ADDENDUM #4

MSAD #72
PRE-K-8 SCHOOL AT MOLLY OCKETT
FRYEBURG, MAINE

MAY 12, 2015

SKE-1

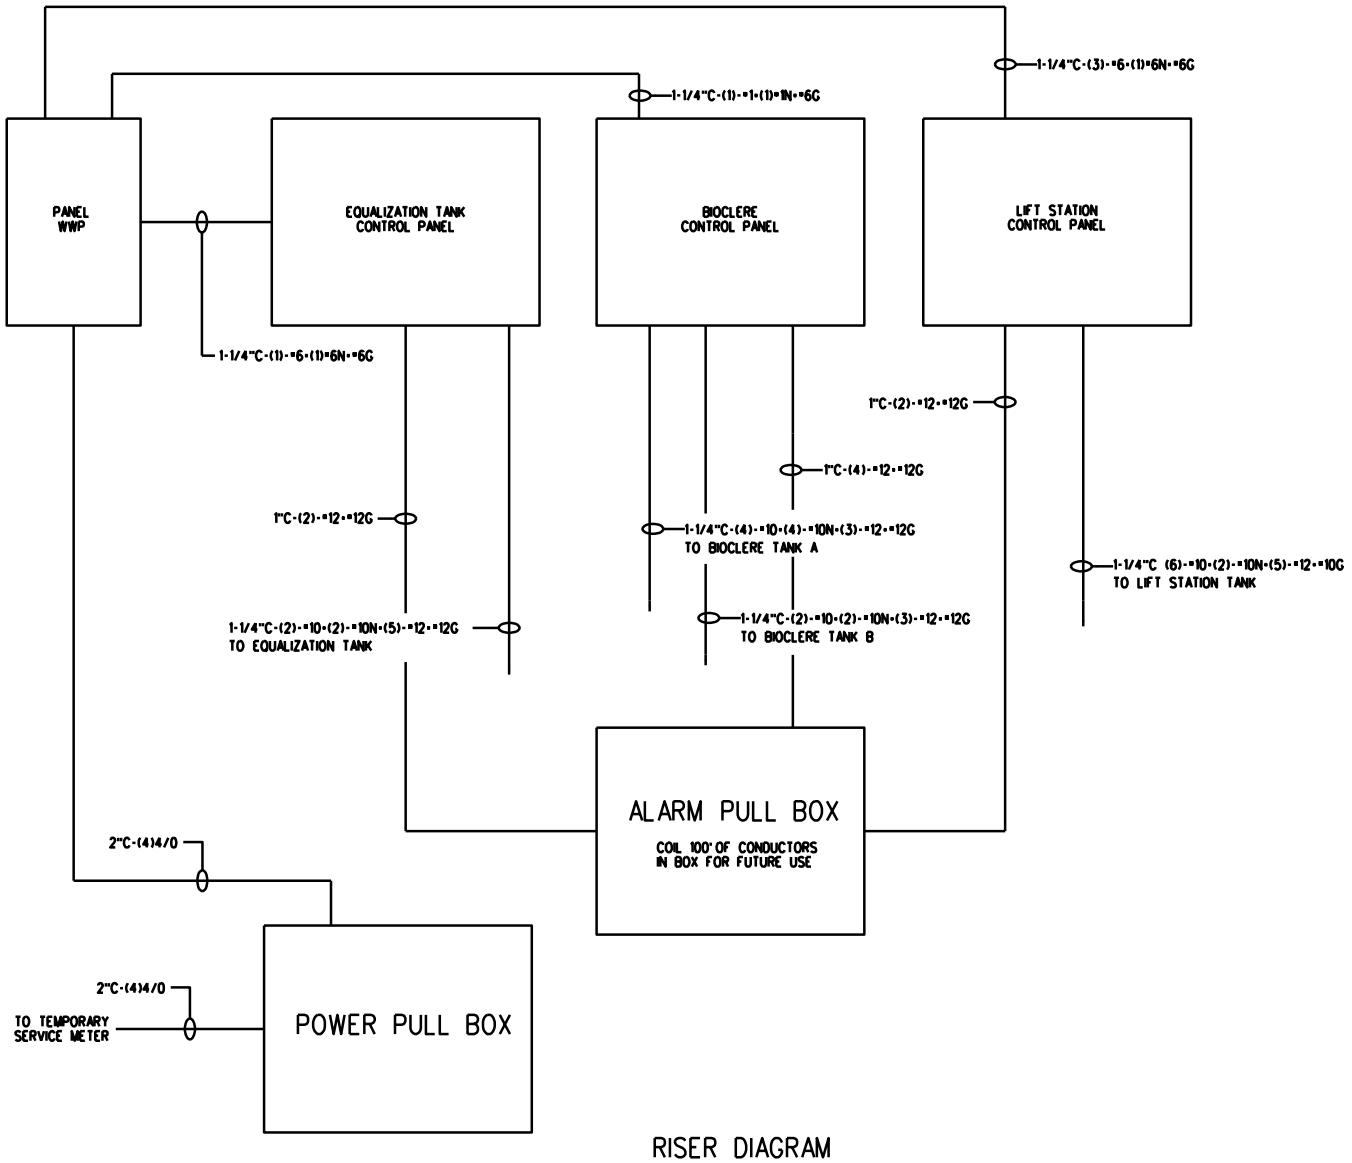
A. *Question: Molly Ockett project calls for us to supply and install a 200 amp 3 phase temporary service for the septic equipment. Plans show wiring for single phase. 1 hot, 1 neutral and 1 ground. Please clarify.*

Response: The power riser diagram has been revised as shown on SKE-1 attached to this addendum.
